OS-PCN-2021-019-A

**Standardization of ceramic substrate
processing method for same OSRAM
OSTAR® Stage product family**

Customer information package

OS QM CQM | 15.07.2021

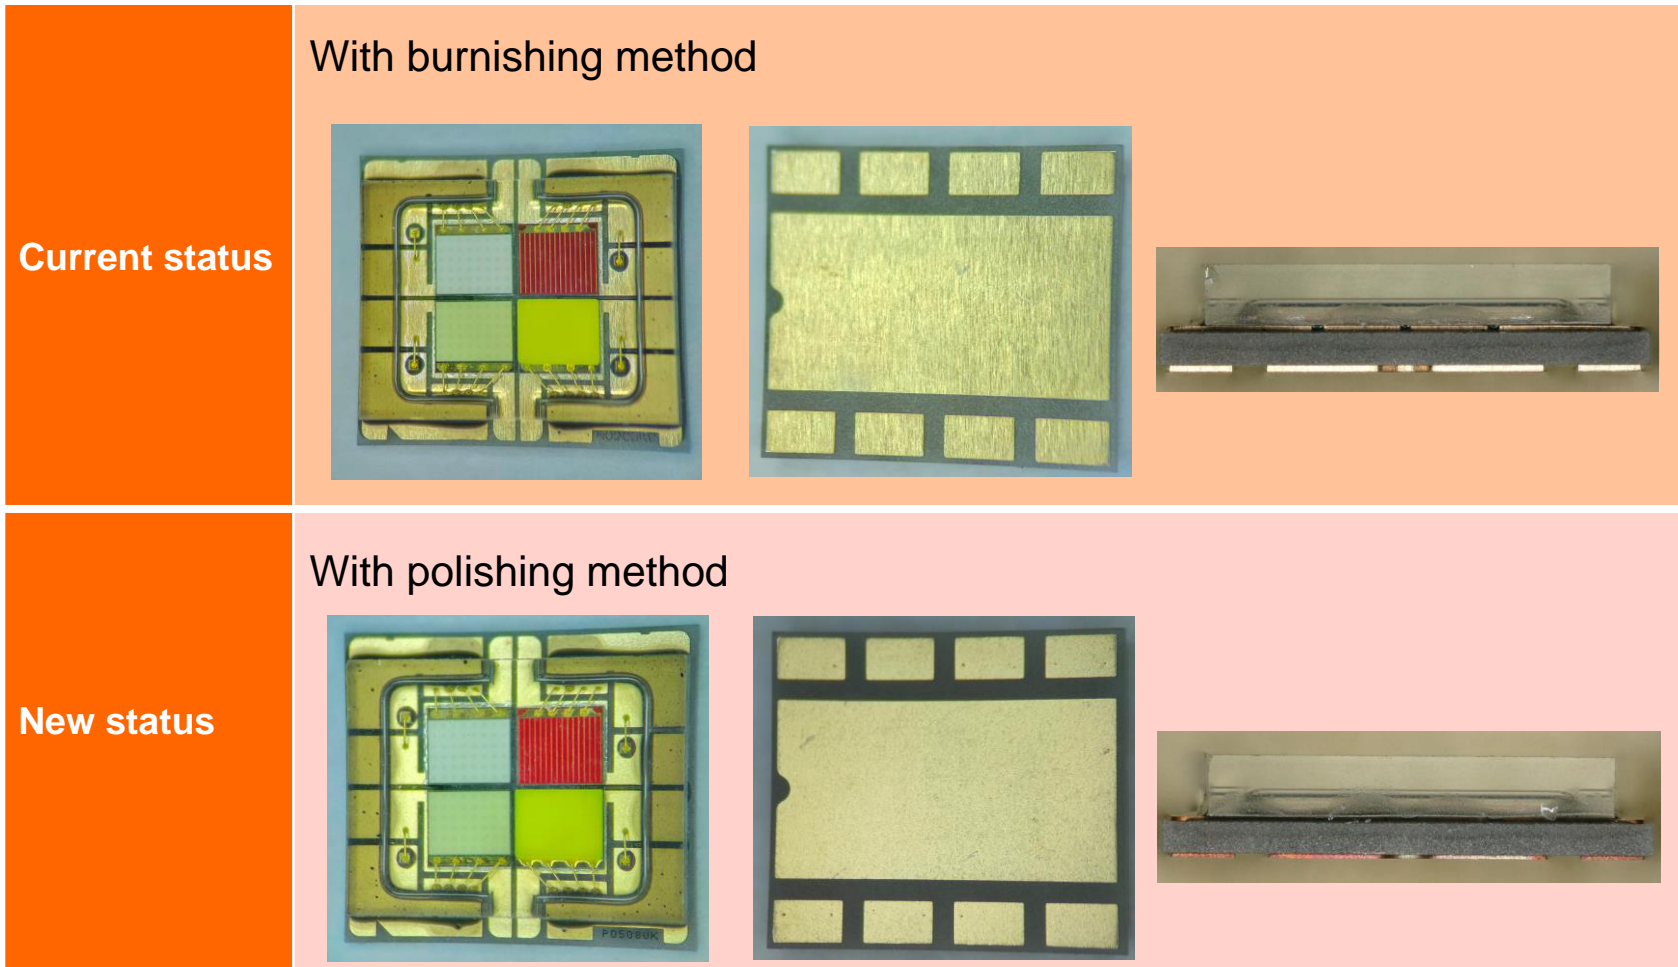
- Standardization of ceramic substrate with metallization processing method for the same OSRAM OSTAR® product family
- To ensure long term material supply on same type of ceramic substrate

- No change in product function and reliability
